PLANNING BOARD REPORT
PORTLAND, MAINE
150 Riverside Street
Self-Storage Facility
Level III Site Plan
PL-000310-2018
Applicant: Patagon Storage, LLC

Submitted to Portland Planning Board Workshop Date: October 23, 2018	Prepared by: Christian Roadman Date: October 19, 2018
---	--

Proposed front (east) building elevation (image provided by applicant team)

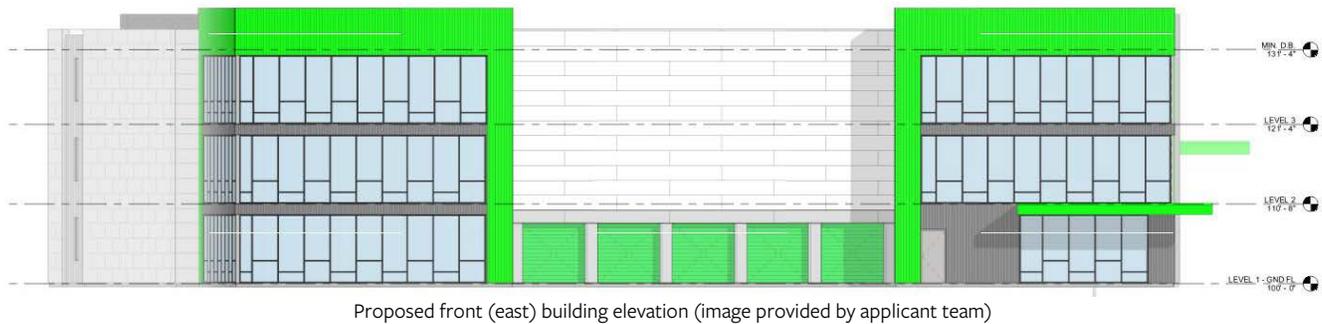
The B-4 zone does not have associated design standards. However, the applicant must submit an elevation for the back (west) side of the building. Duplicate elevation documents (attachments P11 and P12) detail the other sides of the building.
